18-OCT-2024 10:53 C:\Users\Anthony.Reass\Roosi Transportation Group, Inc\Projects - Documents\Project Files\18_105 De\DOT Laurel Design\CADD\Sheets\501.dgn

ADDENDA / REVISIONS		NOT TO SCALE	LAUREL RAMBLE PHASE II	CONTRACT	BRIDGE NO.	N/A	INDEX OF SHEETS	SECTION
				T202120006	DESIGNED BY: A. REASS			ROSSI
				COUNTY	CHECKED BY: S. MCEVILLY	SHEET NO.		
				SUSSEX		2

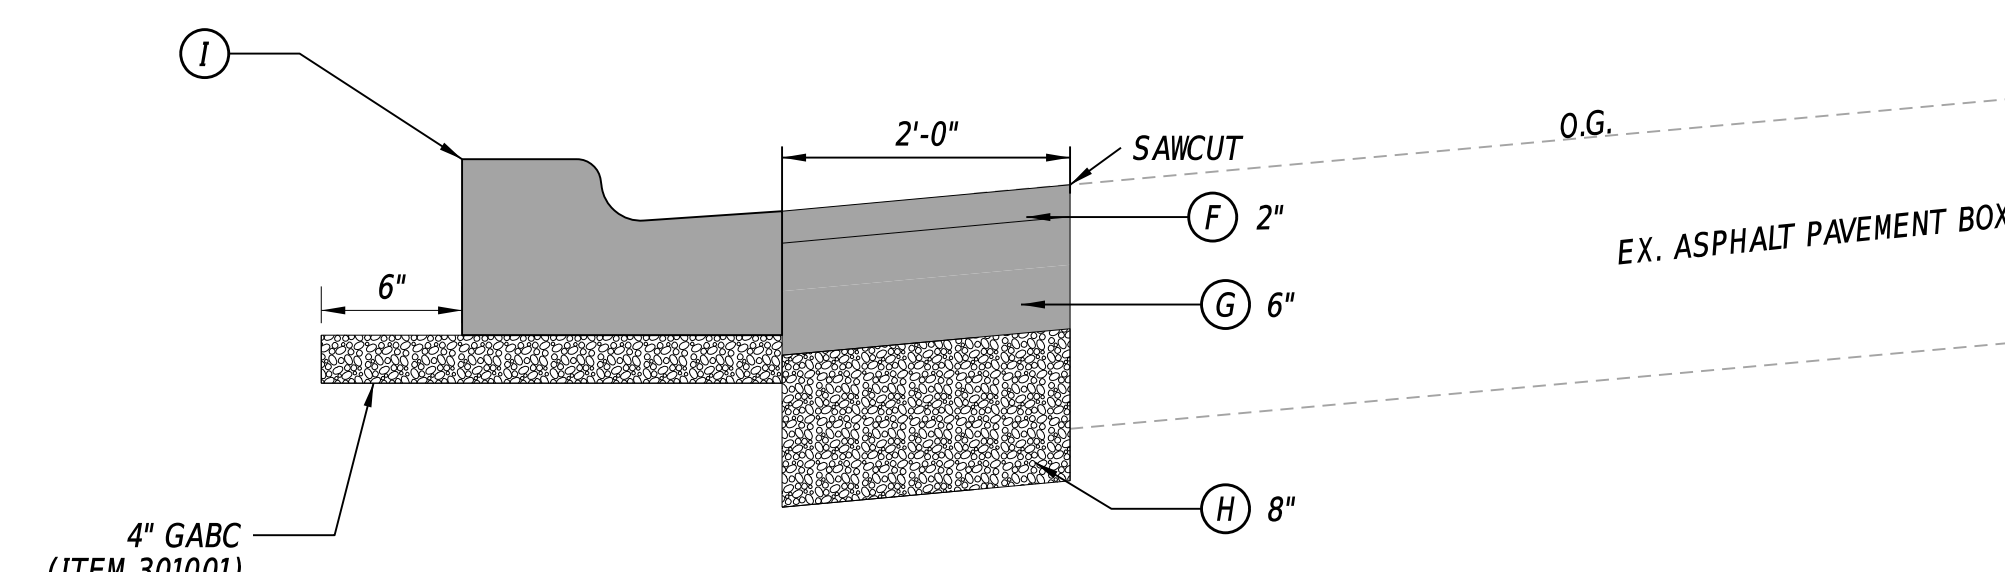
ADDENDA / REVISIONS

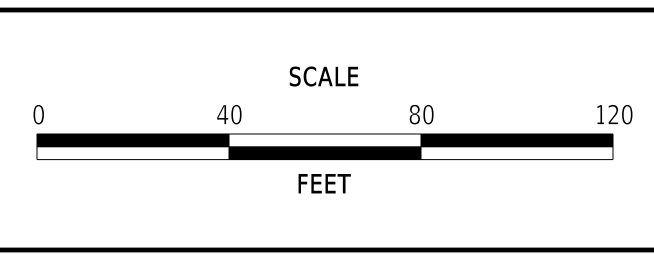
ADDENDA / REVISIONS

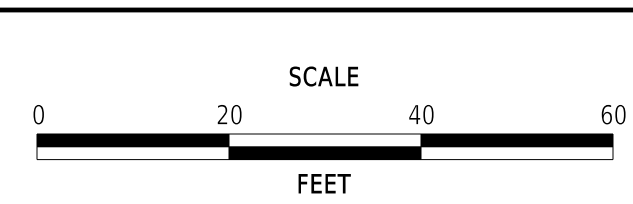
ADDENDA / REVISIONS

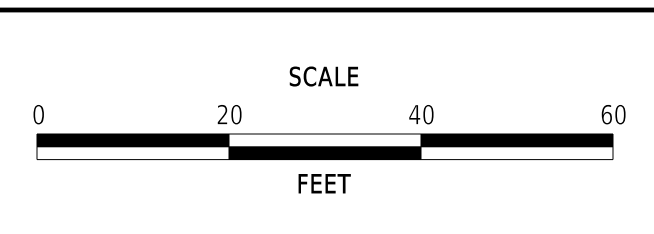
ADDENDA / REVISIONS

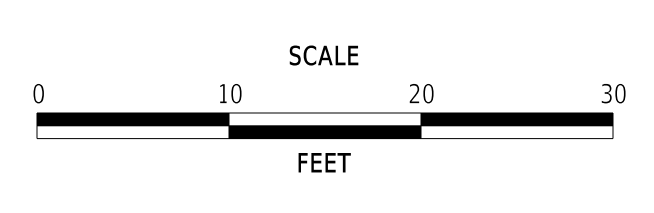
ADDENDA / REVISIONS

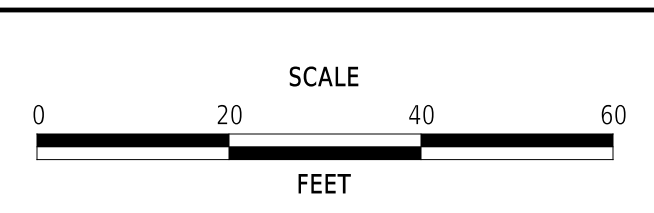
ADDENDA / REVISIONS

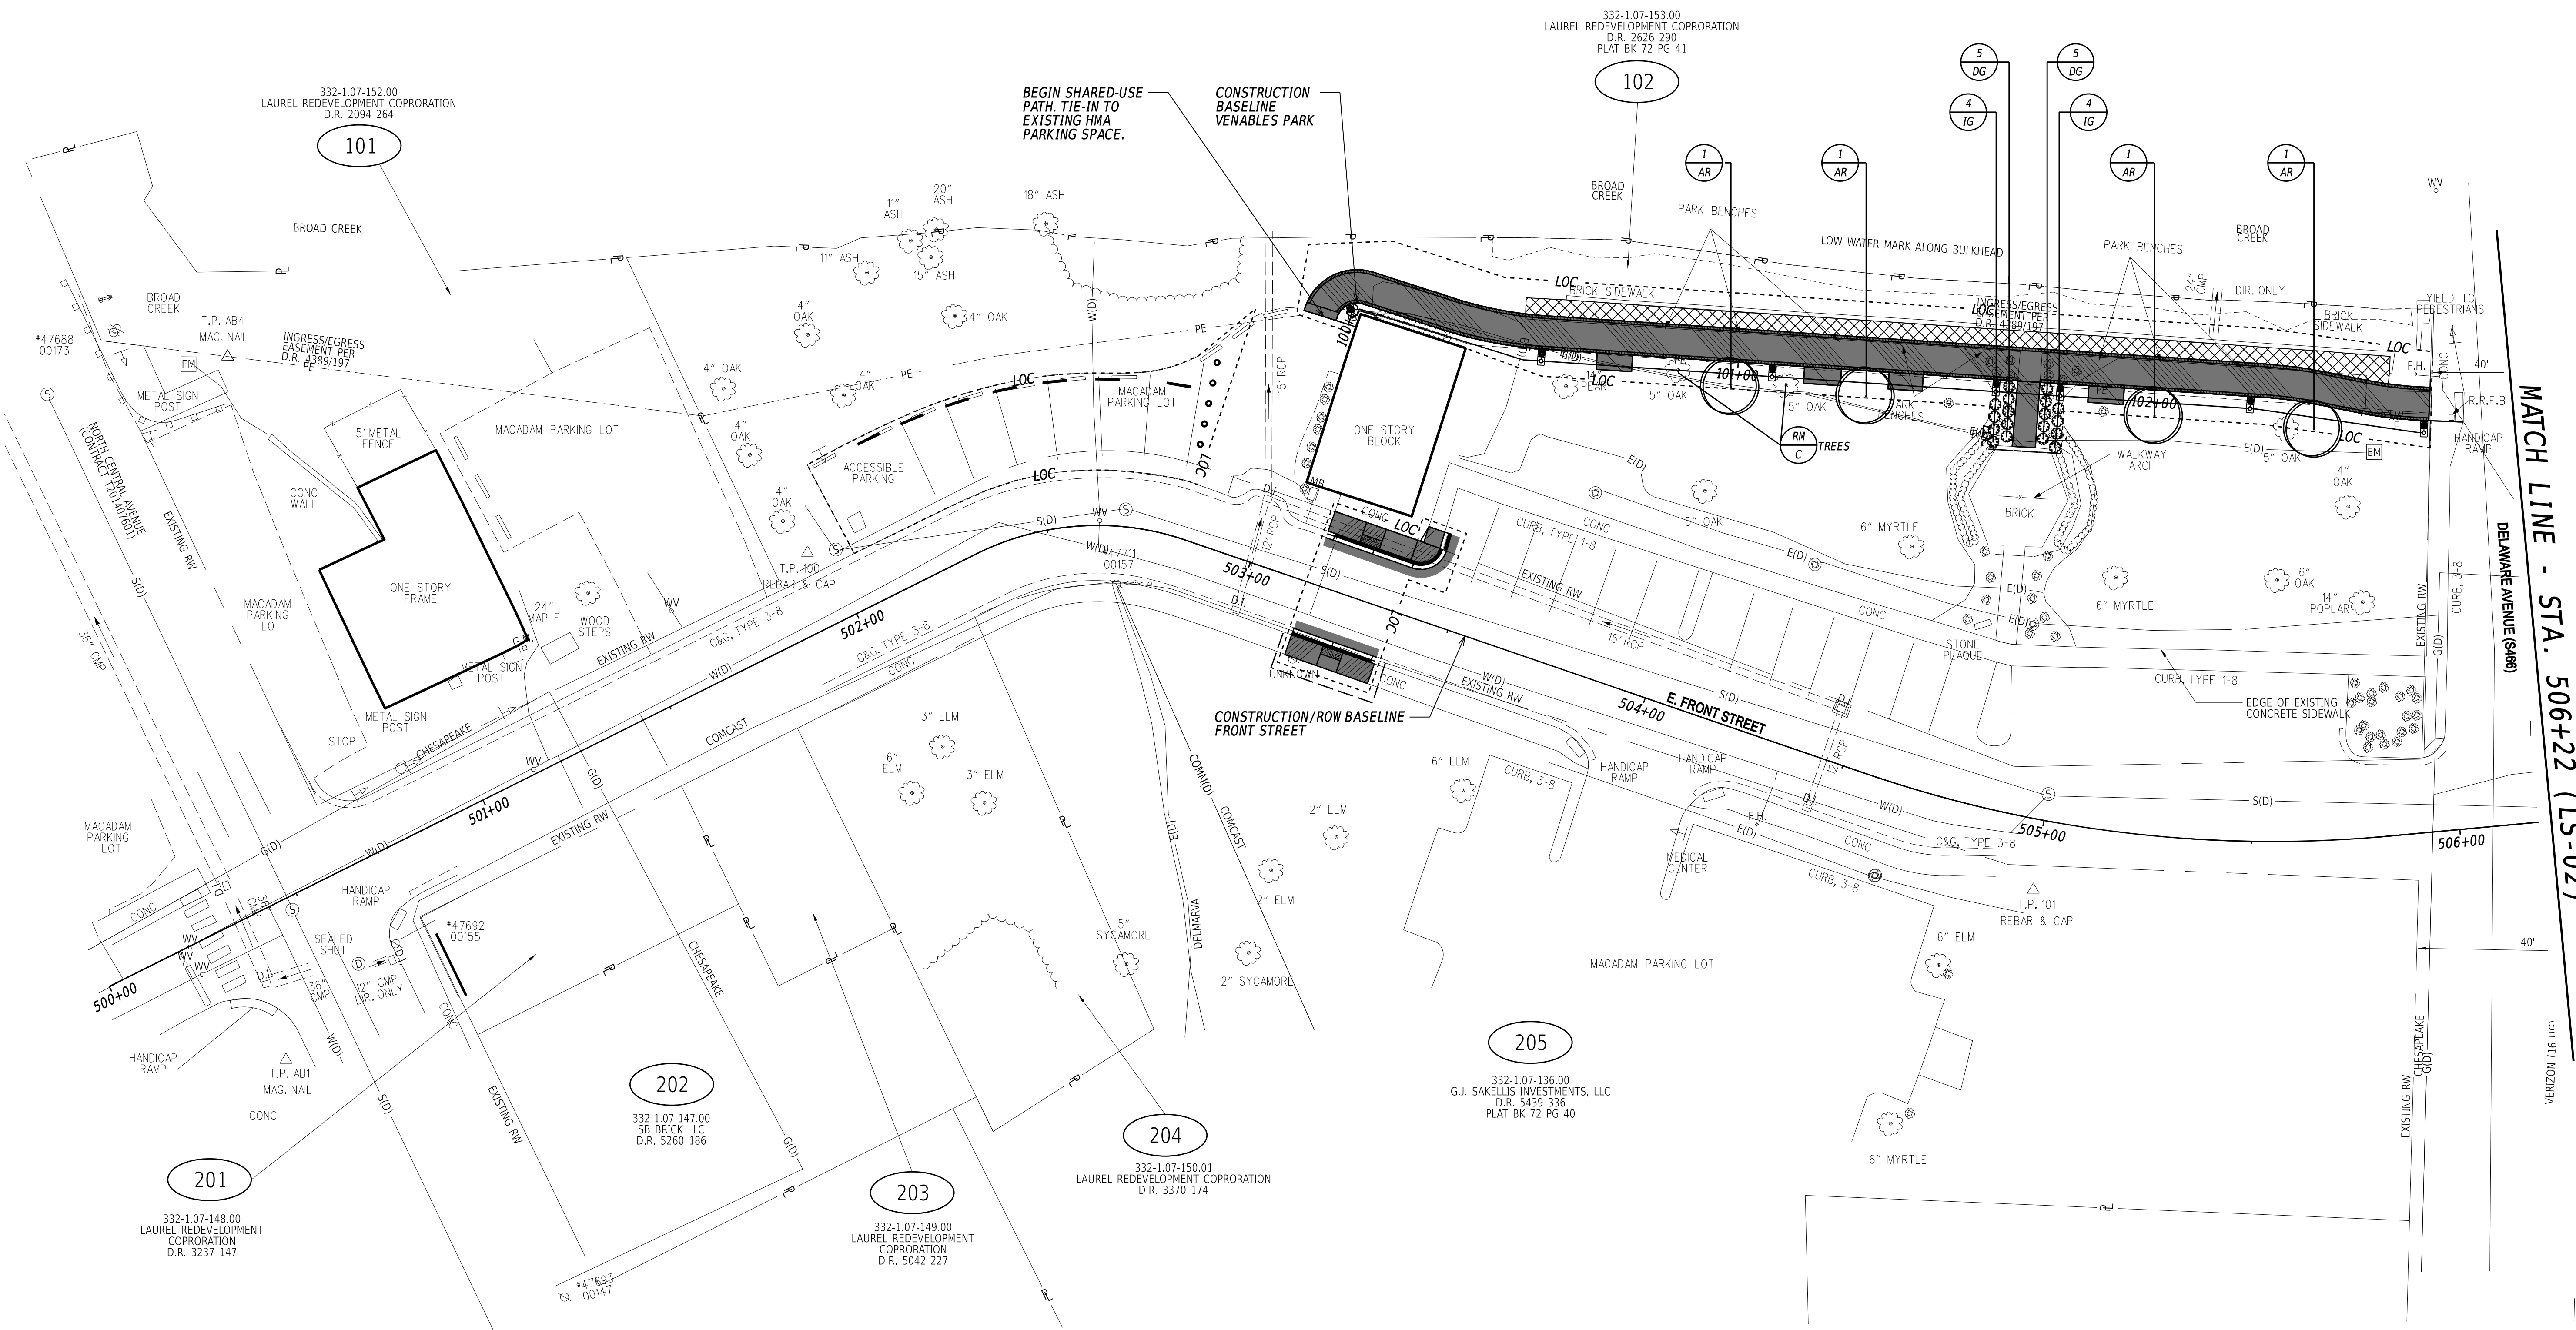
ADDENDA / REVISIONS

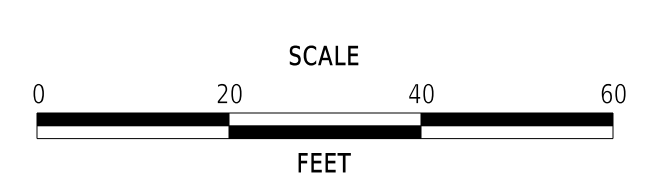
ADDENDA / REVISIONS

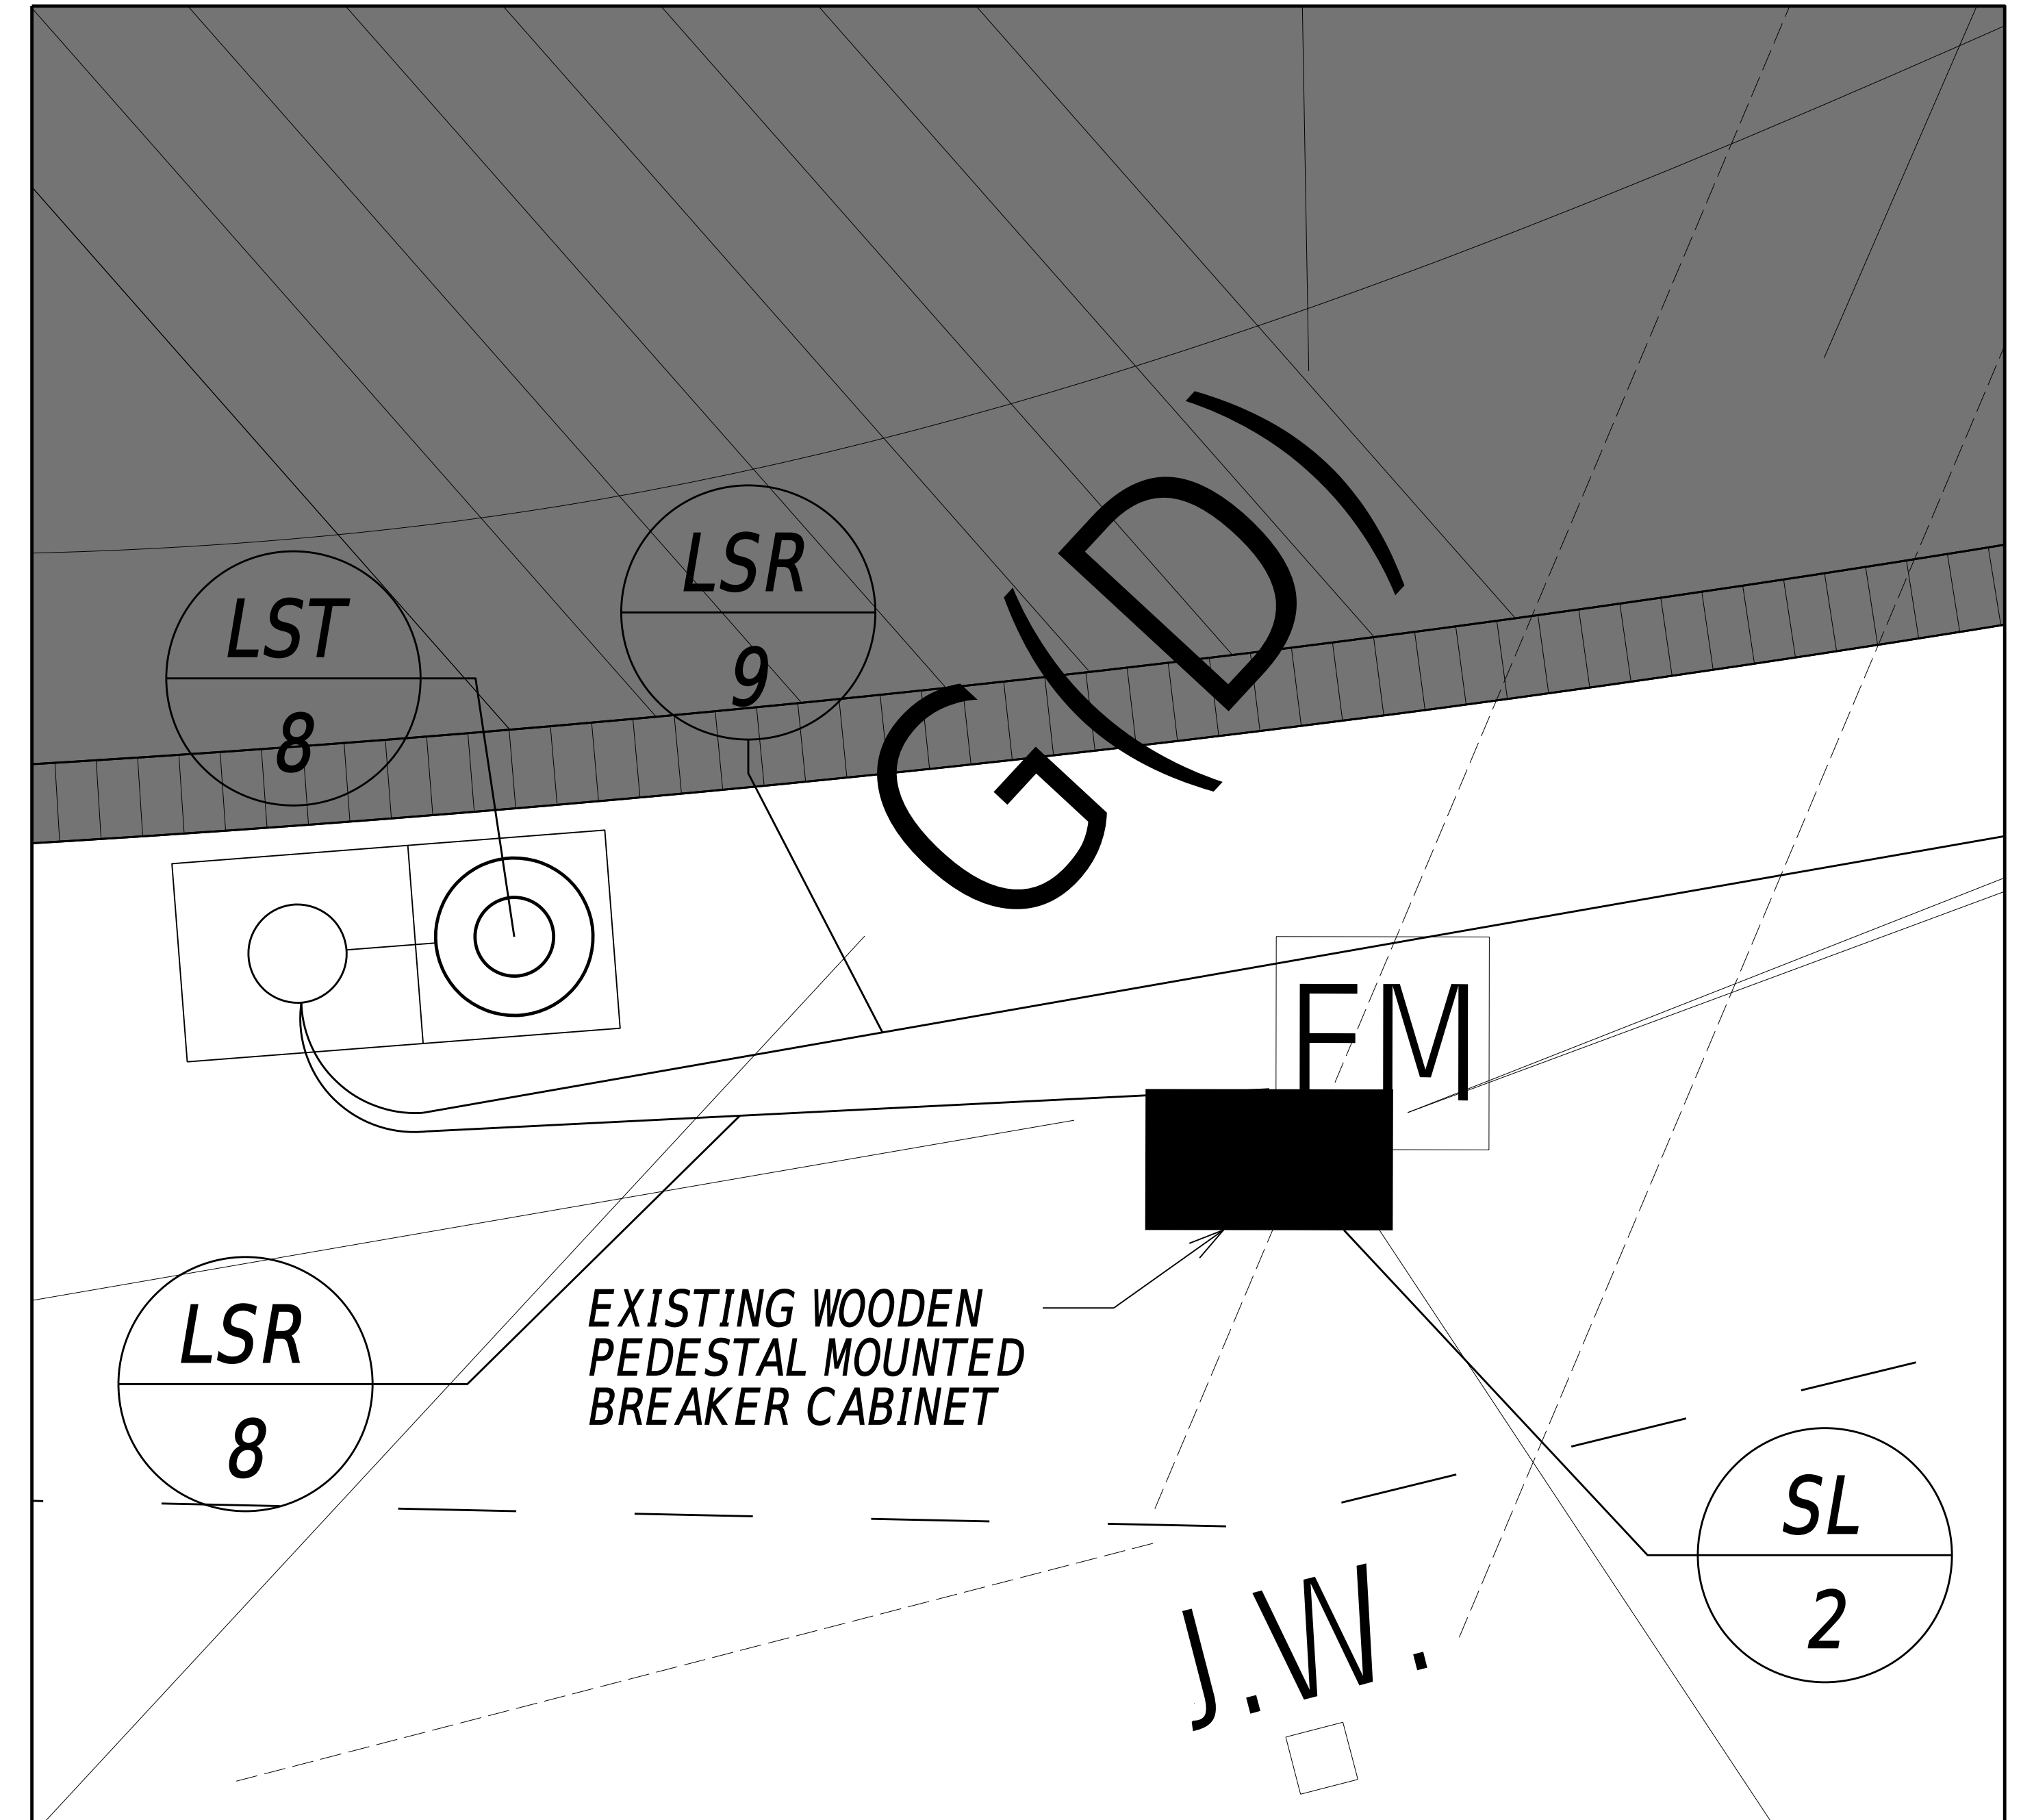
ADDENDA / REVISIONS		NOT TO SCALE	LAUREL RAMBLE PHASE II	CONTRACT	BRIDGE NO.	N/A	SERVICE LOCATION DETAILS	SECTION
				T202120006	DESIGNED BY:	A. REASS		ROSSI
		COUNTY	CHECKED BY:	S. MCEVILLY		SHEET NO.		27
		SUSSEX
